From: BRYAN Martin (EXT) [Martin.Bryan.ext@areva.com]
Sent: Thursday, June 10, 2010 3:16 PM
To: Tesfaye, Getachew
Cc: Hearn, Peter; KOWALSKI David J (AREVA NP INC)
Subject: FW: DRAFT RESPONSES for FSAR Chapter 9 Weekly NRC Telecon
Attachments: Blank Bkgrd.gif; RESPONSE RAI 345 Supp 1 Q.09.02.01-49(c+d).pdf; RESPONSE RAI 345 Supp 1 Q.09.02.01-33.pdf; RESPONSE RAI 345 Supp 1 Q.09.02.01-44.pdf; RESPONSE RAI 345 Supp 1 Q.09.02.01-47.pdf; RESPONSE RAI 356 Supp 1 Various Questions.pdf; RESPONSE RAI 345 Supp 1 Q.09.02.01-31(j).pdf

Please transmit to Getachew Tesfaye the attached partial set of DRAFT responses to RAI 345 and 356 questions. These responses will be discussed at tomorrow's (6/11/10) FSAR Chapter 9 Weekly Telecon/GoToMeeting with the NRC.

QUESTIONS for Balance of Plant Branch 1 (AP1000/EPR Projects) (SBPA)

RAI 356
9.2.2-86

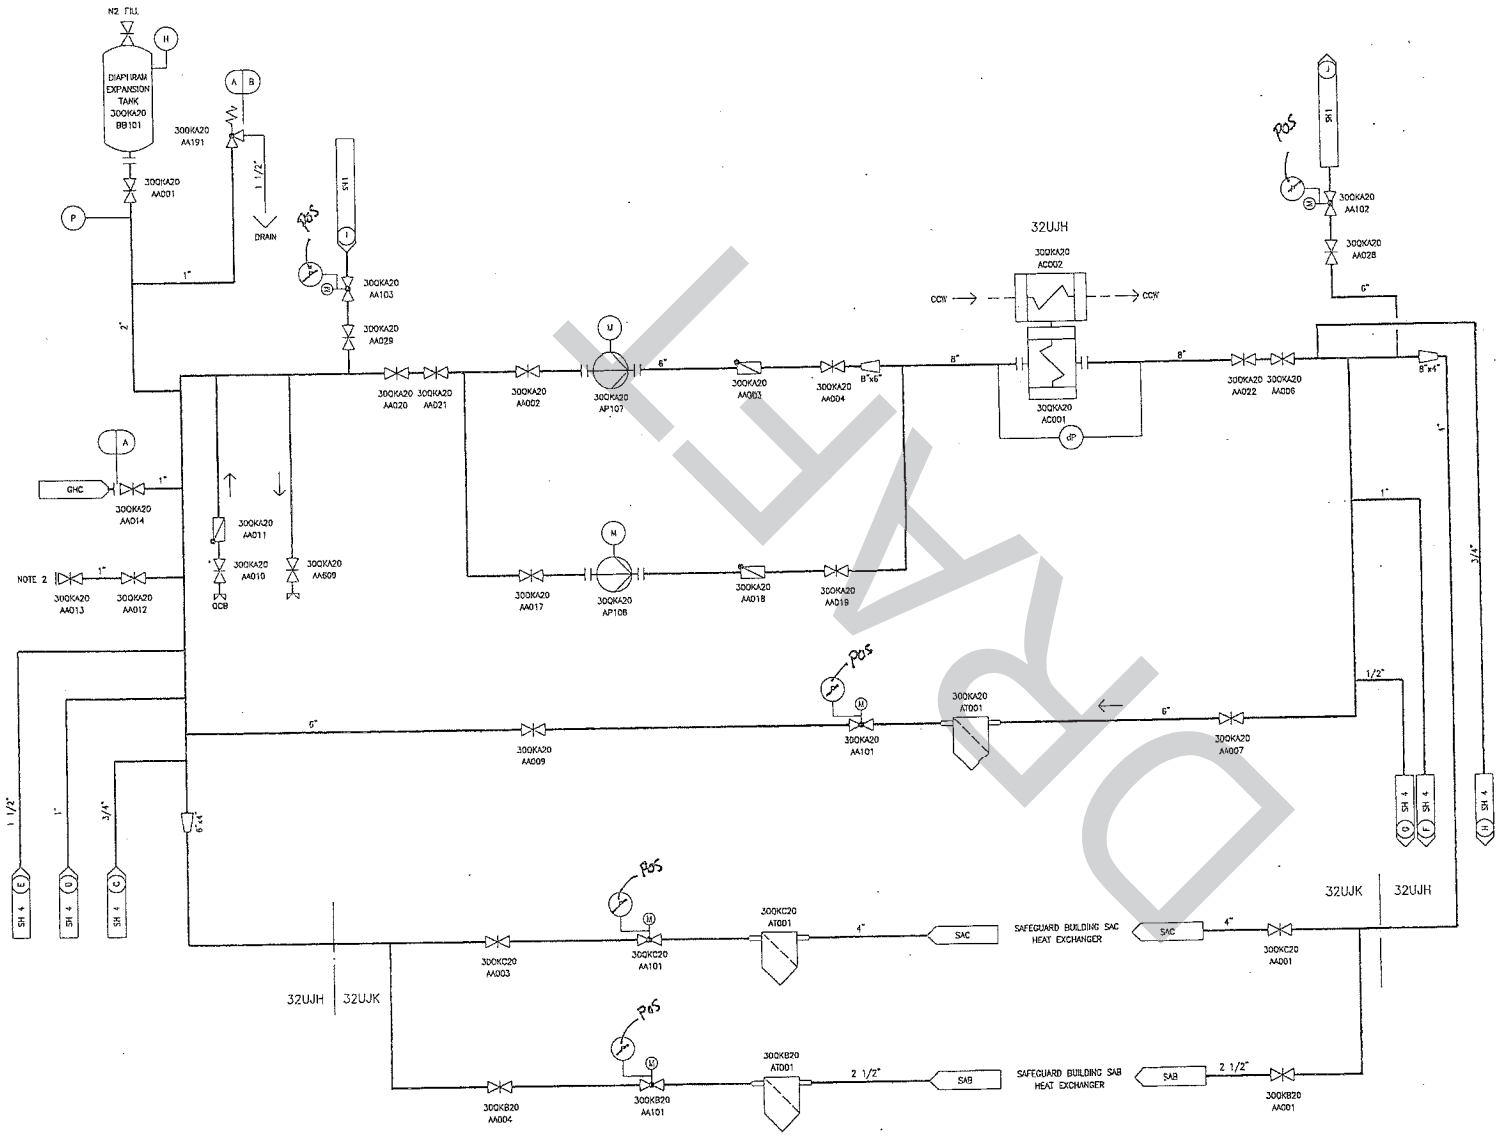
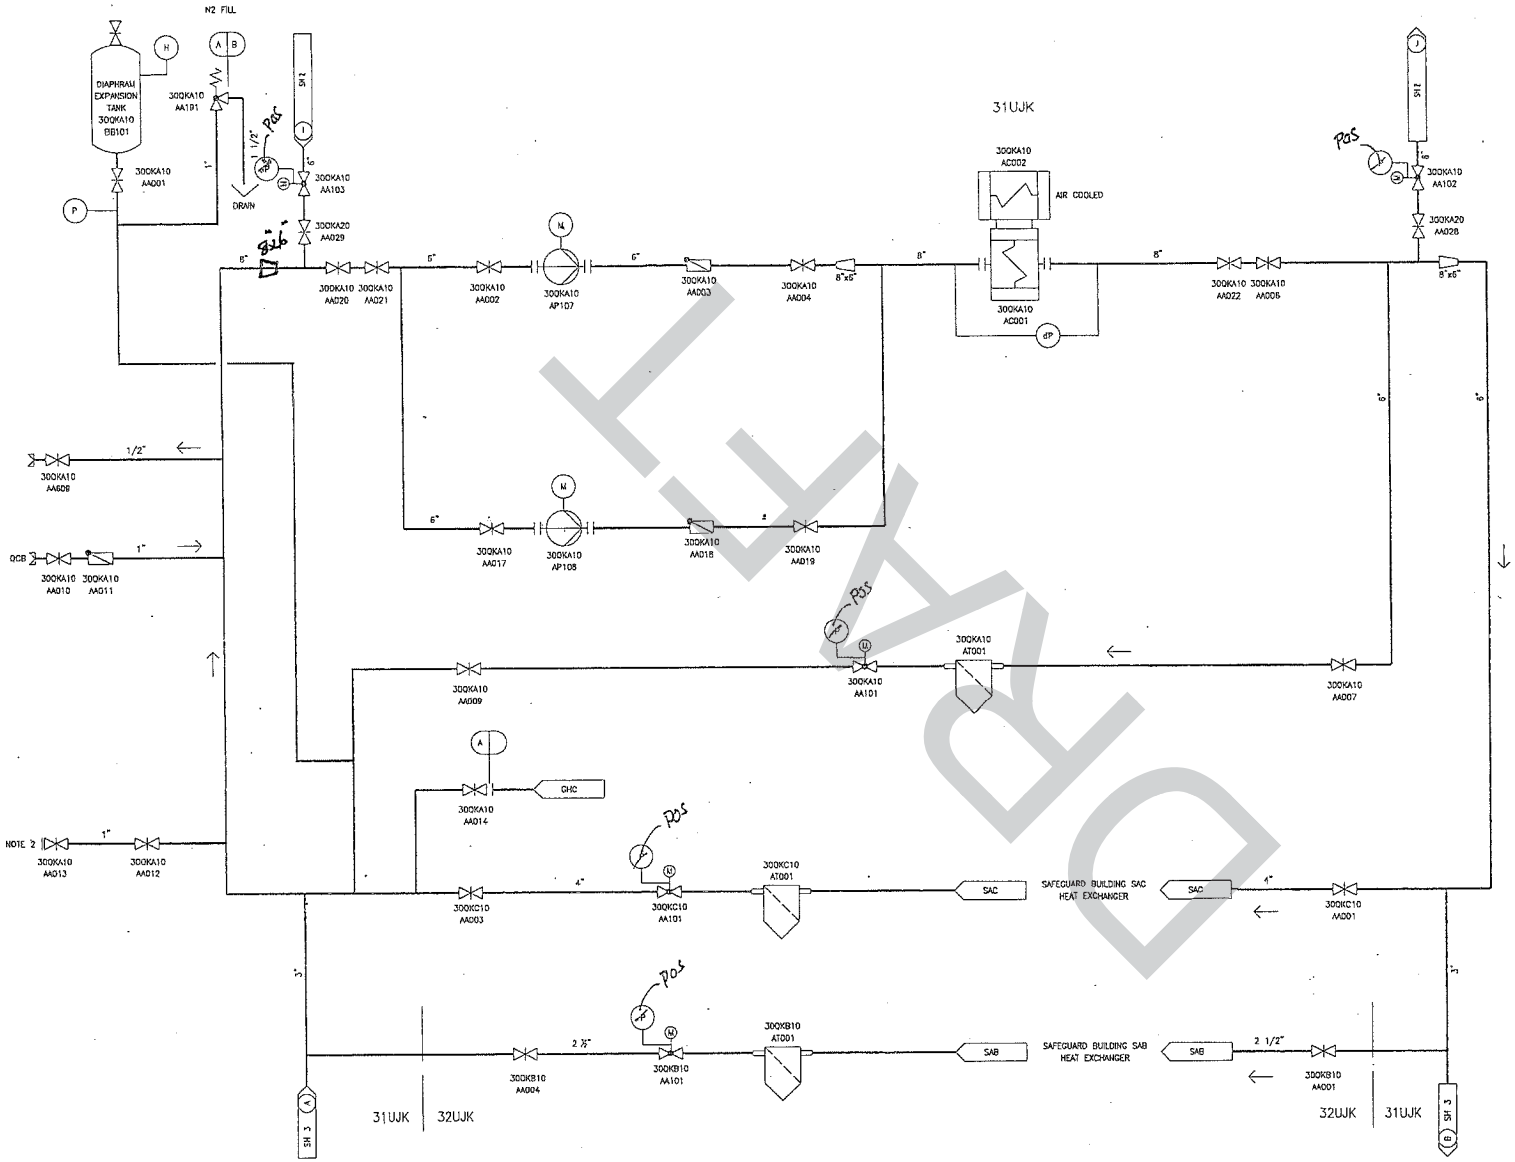
a. Pipe sizes are not shown on the Tier 2, FSAR Figure 9.2.8-1, and the system description does not explain the criteria that were used in establishing the appropriate bounding pipe sizes (such as limiting flow velocities from conceptual/preliminary design studies).

c. Tier 2, FSAR Figure 9.2.8-1 does not show the location of the indications display (e.g., local, remote panel, control room), and does not identify the instruments that provide input to a process computer and/or have alarm and automatic actuation functions.

d. Tier 2, FSAR Figure 9.2.8-1 does not identify the normal valve positions, the valves that are locked in position, and the valves that have automatic functions. These design features should be described.

e. Tier 2, FSAR Figure 9.2.8-1 does not show specific set point for system alarms (including head tank) and relief and the bases for these set points are not explained in the system description.

f. Isolation valves for taking components out of service for maintenance are not shown on the Tier 2, FSAR Figure 9.2.8-1.

a. Pipe sizes will be added to Tier 2, FSAR Figure 9.2.8-1. Tier 2 FSAR section 9.2.8.1 will be revised to explain the criteria that were used in establishing the appropriate bounding pipe sizes.

f. Isolation valves for taking components out of service for maintenance are shown on the Tier 2, FSAR Figure 9.2.8-1 including the addition of isolation valves for the cross-tie MOVs.
g. A description of the filters for the flow control valves has been added to Tier 2, FSAR Section 9.2.8.

FSAR Tier 2 Section 9.2.8.3.2 and Figure 9.2.8-1 will be revised to add requirements for makeup storage in the expansion tank as indicated in the attached mark-ups.
